IEEE 802.3 Interpretations Report

July 15th, 2004
Portland, OR
David Law

Interpretation Number: 1-07/04

Topic: Auto-Negotiation state diagram

Relevant Clause: Figure 37-6

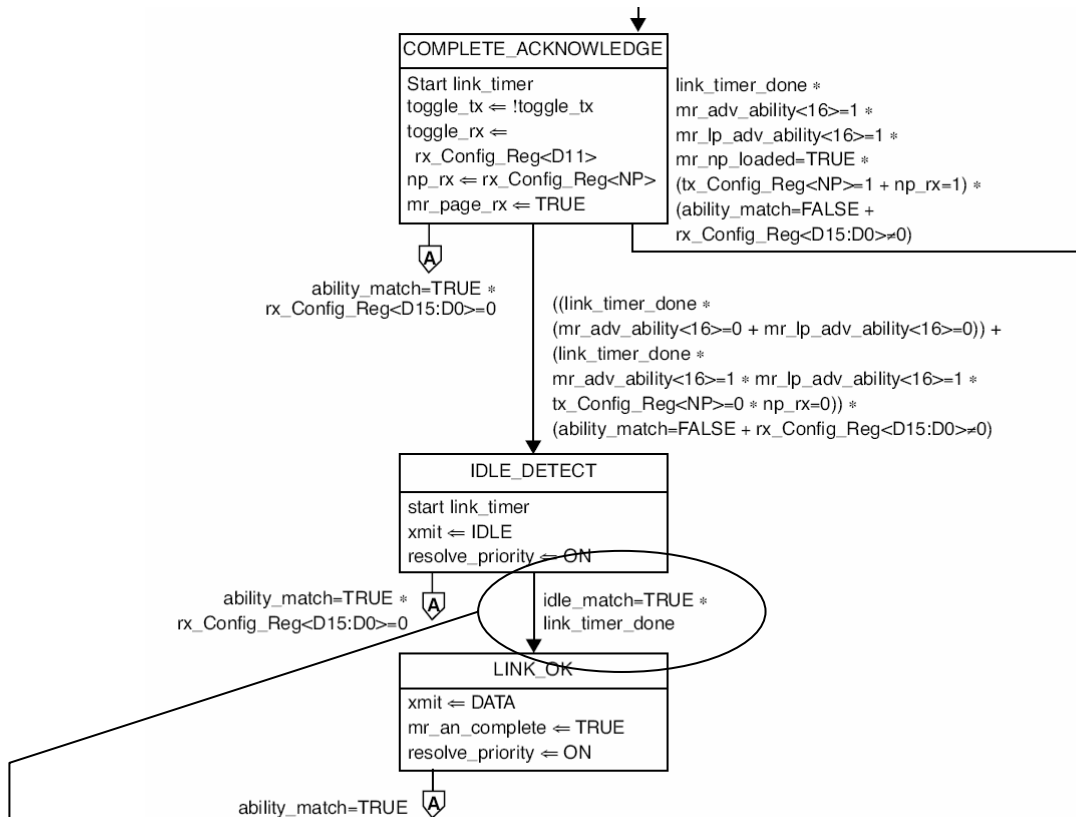
My question is regarding the IEEE802.3z referring to figure 37-6.

I was wondering if anyone can help me with a problem I face. In the IEEE 802.3z figure 37.6 auto negotiation block diagram, in the IDLE_DETECT state, we are expecting IDLE symbol and also link time done to move to LINK_OK state. Let's say one of the link partner link timer is 10.5ms and the other is 11.5ms. So what will happen is the link partner with timer of 10.5ms will go to the LINK_OK state first while the link partner with timer of 11.5ms will still be in the IDLE_DETECT state.

My question is when the first link partner goes into the LINK_OK and sends data to the link partner that's still in the IDLE_DETECT. What should happen? Should the MAC device in IDLE_DETECT resets or proceed on?

The state IDLE_DETECT does not relate to the MAC but instead the PHY.

As defined in Fig 37-6 the transition from IDLE_DETECT to LINK_OK requires $\text{idle_match}=\text{TRUE} * \text{link_timer_done}$. The condition $\text{idle_match}=\text{TRUE}$ is defined in 37.3.1.2 as "Three consecutive // ordered_sets have been received. The match count is reset upon receipt of /C/.". If the link partner's timer is 10.5 msec, that link partner has sent plenty of // ordered_sets to make this condition valid. Packets transmitted from the link partner, which do not include /C/, will not reset idle_match. Therefore received frames will be ignored while this PHY's link timer is timing out for another 1 msec, but then the state diagram does indeed proceed on to the LINK_OK state.
